**THE
NATIONAL
BOARD**
OF BOILER AND
PRESSURE VESSEL
INSPECTORS

SUBGROUP ON HISTORICAL BOILERS

AGENDA

*Meeting of July 19, 2010
Columbus, Ohio*

A07 FIGURE S2.13.9.2 Unstayed Area Crack Repair

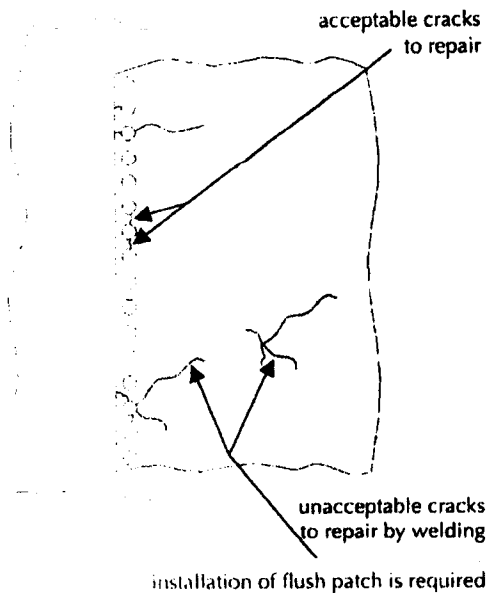
NB10-0103 Part 3 Part 3 S2.13.9.2 SG on Historical Resolve conflict of text and figure S2.13.9.2. A task group of T. Dillon and M. Wahl has been assigned. (Attachment 2, pg. 1)

FIGURE S2.13.12.2 Stayed Area Crack Repair

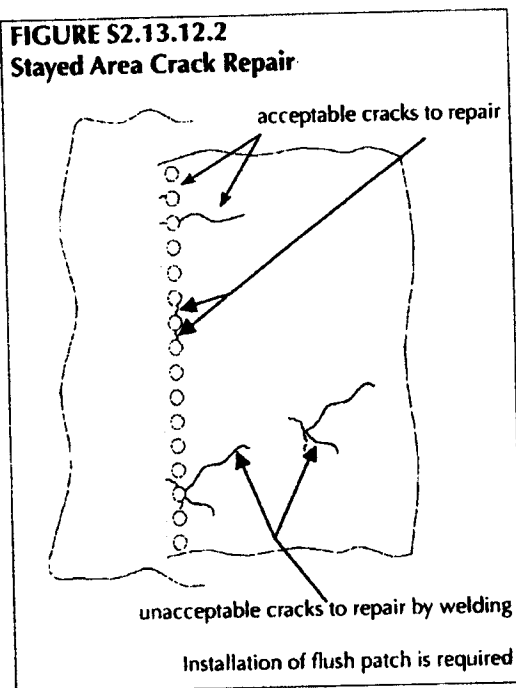
NB10-0105 Part 3 S2.13.12.2 SG on Historical Remove a) from paragraph and revise wording so both paragraphs are clear. Clarify rules for Welded Flush Patches in Tubesheets. (Attachment 2, pgs. 5-6)

After discussion it was determined that the Figure is wrong. A new Figure will be provided by the Task Group of Tom Dillon and Mike Wahl.

**A07 FIGURE S2.13.13.1
Rivet Heads**

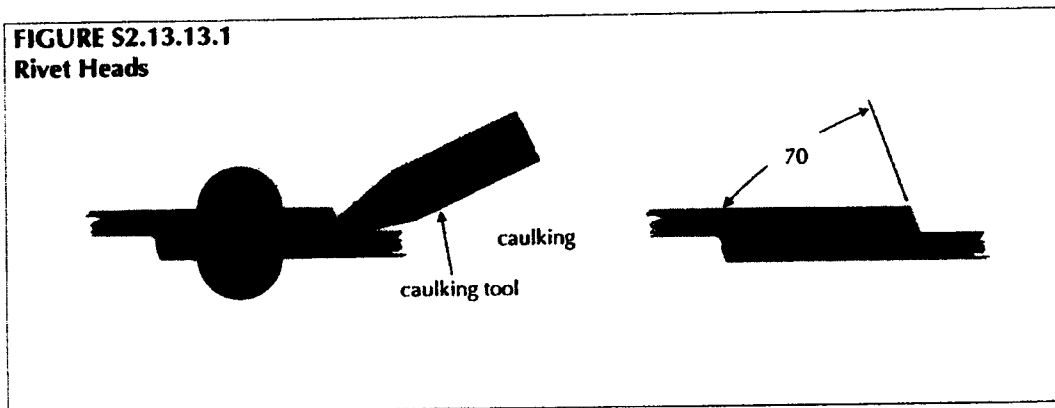
NB10-1004 Part 3 Figure S2.13.13.1 Figure and title are incorrect. Figure should show caulking of seam and rivet heads. The title should reflect caulking of seam and rivet heads also. New drawing will be supplied to committee members by Tom Dillon for review and approval. (No Attachment)
